Service Bulletin

Bulletin No.: PIC5822

Subject: Water On Floor And/Or Carpet

Models: 2013 Chevrolet Malibu

3339515

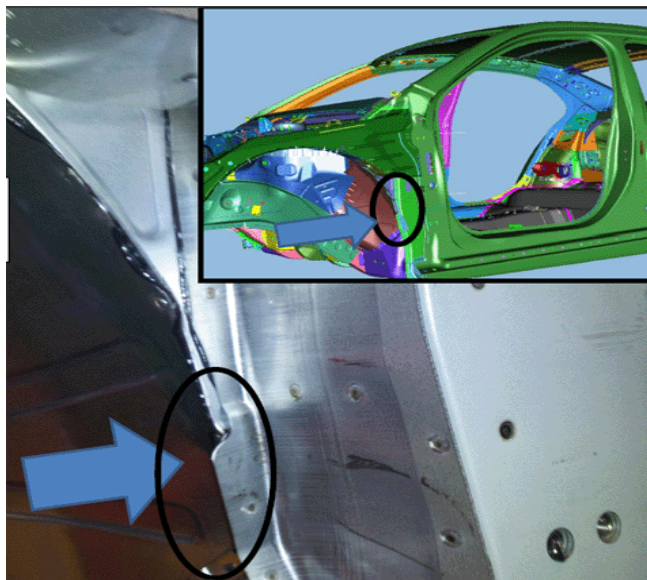
Front wheel house flange may have a void in the sealer.

Seal the void using a thumb grade sealer (also referenced as a "heavy-bodied caulking material" in SI) pushed into the void from the wheel opening. For location of flange see the graphics below.
